MFN 06-128

Docket No. 52-010

**Subject: Response to NRC Request for Additional Information Letter No. 14
Related to ESBWR Design Certification Application – Reactor Vessel
– RAI Numbers 5.3-1 through 5.3-12**

Figure 5.3-1. Minimum Temperatures Required Versus Reactor Pressure for Hydrotest — Core Not Critical (Representative curve for the ESBWR)

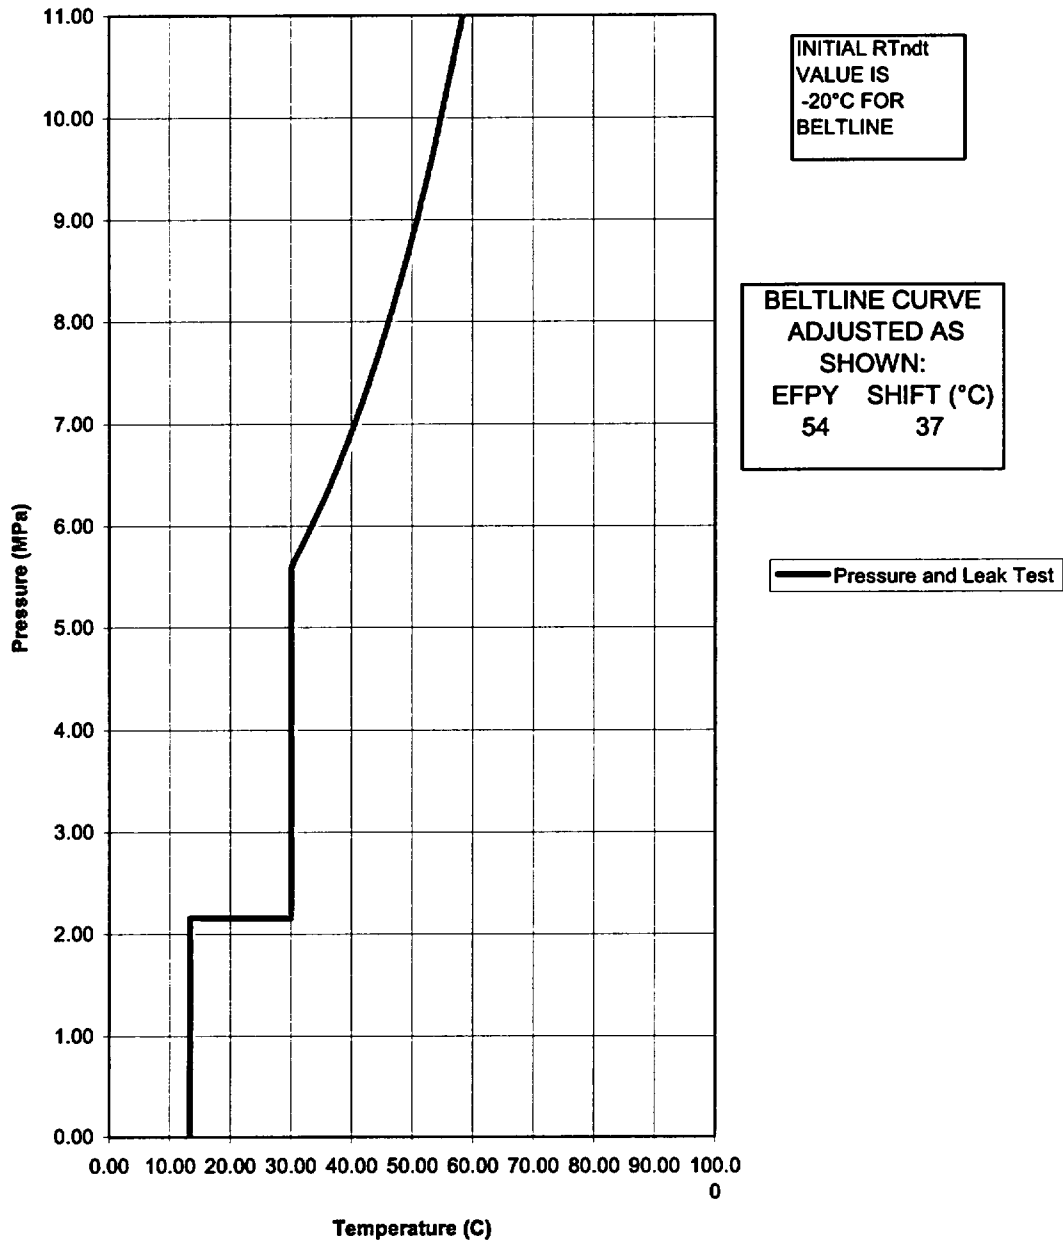
Provide information regarding the derivation of the pressure-temperature (P/T) limit curves provided in the DCD. Identify any deviations from the recommended calculational procedures in Revision 1, July 1981, of Section 5.3.2 of the Standard Review Plan (SRP) and confirm conformance with Appendix G to 10 CFR Part 50.

Clarify the intent of the P/T curves provided in the DCD (e.g., representative or bounding).

The P/T limit curves provided in the DCD are representative of typical BWR P/T curves.

The pressure/temperature limit curves in Figures 5.3-1 and 5.3-2 **are representative for the ESBWR. They** are based on the requirements of 10 CFR 50 Appendix G and Regulatory Guide 1.99.

Representative Pressure versus temperature limits for pre-service and in-service tests when the core is not critical are shown in Figure 5.3-1. Pressure/temperature curves using plant specific data such as materials, fluences and stresses will be developed prior to plant hydrostatic test.
